MVC Pulse South Beach and MVC Miami Sales Center
Marriott Ownership Resorts, Inc – South Beach
Miami Beach, Florida

Addendum Number Three

ADDENDUM-003

SK3.1

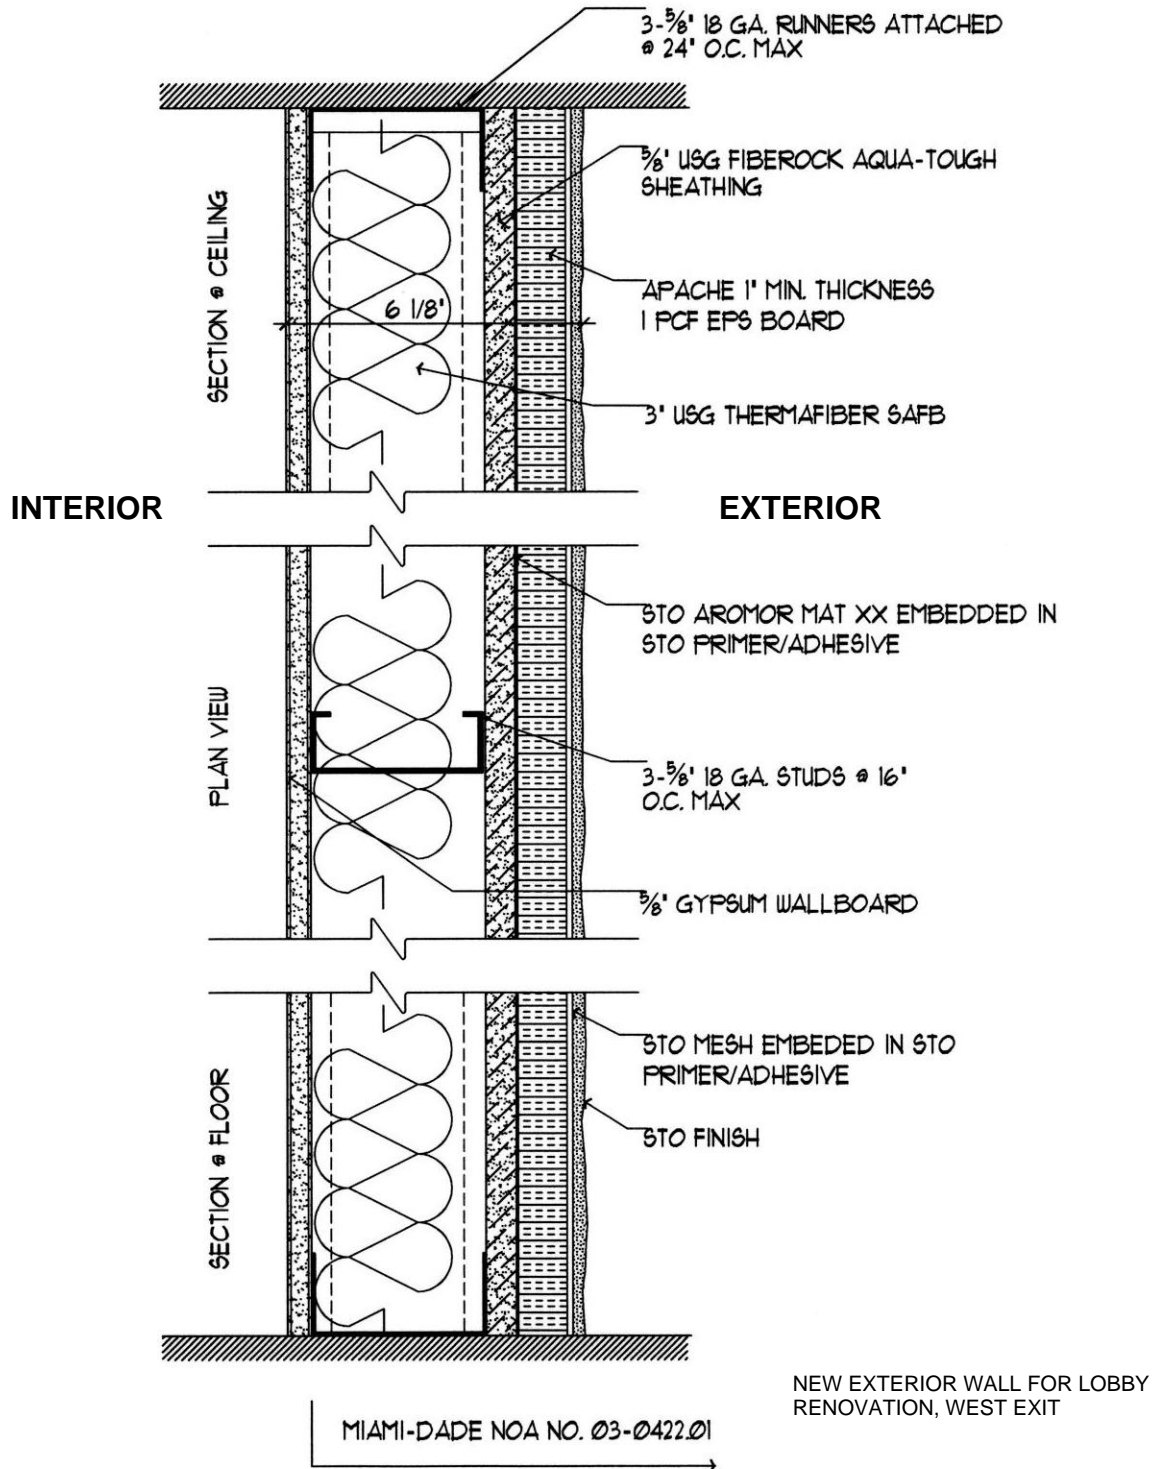
- 16) Are there any structural details (footing/beams/tie in to existing walls) for new exterior door MK 109-1?**

No footing required. New exterior wall to be constructed in accordance with attached detail of existing exterior wall type. Refer to attached sketch SK3-1

A NEW EXTERIOR WALL INFILL
NO SCALE
